TECHNICAL BULLETIN
Bell Helicopter **TEXTRON**

No. 407-03-40

MODEL AFFECTED: 407

SUBJECT: SPARE TAILBOOM ASSEMBLY P/N: 407-030-801-201, /-203, ADDITION OF MISSING SPACER P/N 407-023-800-137

Figure 1. Installation of spacer P/N 407-023-800-137 (sheet 1 of 3).

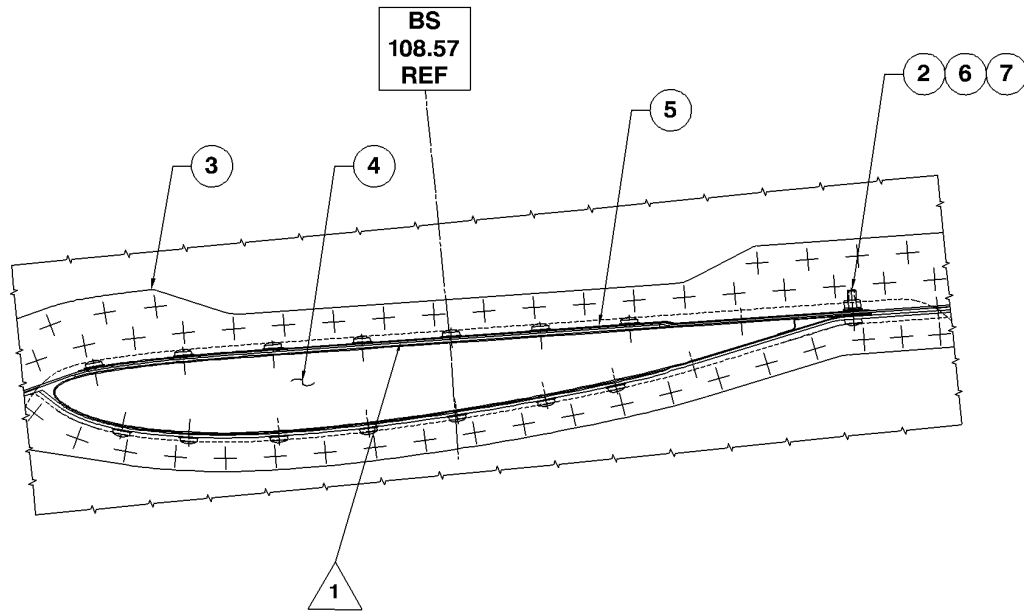
1. Refer to Figure 1, Detail B. Remove screws (1) and washers (2) (qty. 8 each) and aft screw, nut and washer (6,7 and 2) from the upper left stabilizer support (3) and the stabilizer (4) and examine for condition. Replaced damaged hardware as required.

Figure 1. Installation of spacer P/N 407-023-800-137 (sheet 2).

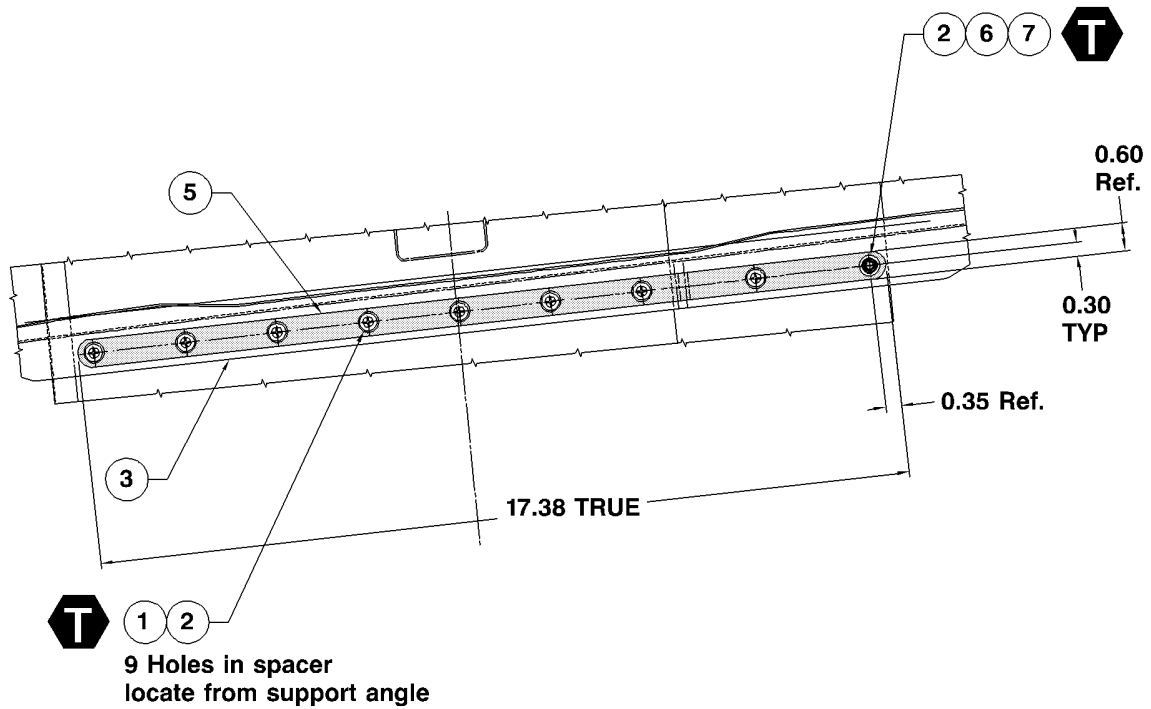
The spacer is to provide additional thickness to the left hand horizontal stabilizer support, at the flange that mates with the horizontal stabilizer. It also helps to prevent the screws from bottoming out into attachment inserts while maintaining commonality of screws and to ensure proper clamp up of the horizontal stabilizer.

2. Use a cloth moistened with Acetone (C-316) and clean the upper surface of the stabilizer support (3).
3. Put the spacer (5) in position on the upper surface of the stabilizer support as shown in Figure 1, Detail B. Hold this position while you mark with a fine tip felt pen, the center of 9 holes that will be in line with the center of each insert in the stabilizer (4).

4. Remove the spacer (5).
5. Use a #40 drill (0.098 inch (2.49 mm) diameter) to pilot drill the centerline of each of the marks made earlier on the spacer (5)

6. Increase (qty 9) holes to final size (0.218/0.224 inch (5.537/5.689mm) diameter), in the spacer (5). Deburr all holes.
7. Finish all bare metal surfaces using Chem Film (C-100) and primer (C-204)

8. Coat the faying surface of the spacer (5) that will mate with the upper surface of stabilizer support (3) with a thin layer of sealant (C-392). Install spacer using screws (1) and washers (2) (qty. 8 each) and aft screw, nut and washer (6,7 and 2).

9. Tighten  the screws (1) and nut (7) attaching the stabilizer (4) to support (3).
10. Ensure that no void exists in sealant squeeze-out and allow to cure.
